SUBJECT: Defense Logistics Agency (DLA) Response to the Nuclear Regulatory
Commission (NRC) Second Round Comments for Curtis Bay Depot
Remediation Plan

RE: Mr. Dominick A. Orlando (NRC) letter to Mr. F. Kevin Reilly (DLA)
dated 9 March 1994

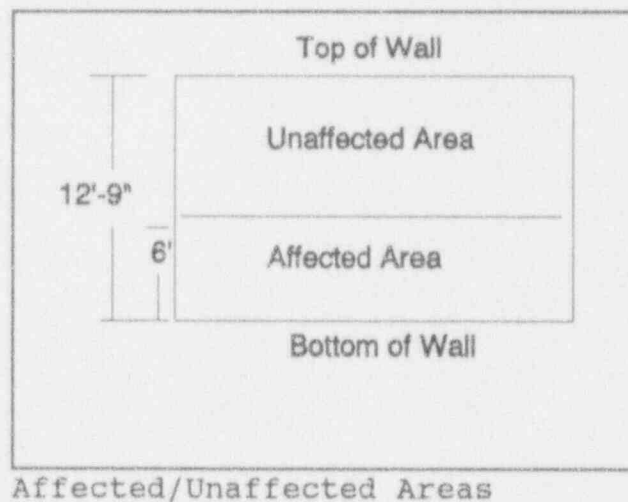
43. Page 7-1, the interior and exterior walls and roofs have been designated as unaffected areas. The interior walls should be considered affected areas unless the characterization survey of the walls proves otherwise. In addition, it is not clear if the characterization survey described in this section is consistent with statements made in section 3 as this section indicates that the walls and roofs will be removed and placed on the ground before characterization while section 7 seems to indicate that characterization will occur while the roofs and walls are in place. Please clarify these statements.

During the meeting on January 19, 1994, between NRC, DLA, RUST, Anne Arundel County and the MdDE, DLA indicated that it felt it was appropriate to classify the lower walls (ie., below 6 feet) and floors as affected areas and classify the upper walls and ceiling as unaffected areas. NRC and MdDE staff indicated that this would be acceptable. Please clarify if DLA still intends to classify the lower walls and floors as affected areas and classify the upper walls and ceiling as unaffected areas or does DLA intend to classify the entire building interior as an affected area.

Please refer to responses #2 and #5 above and simplified drawing.
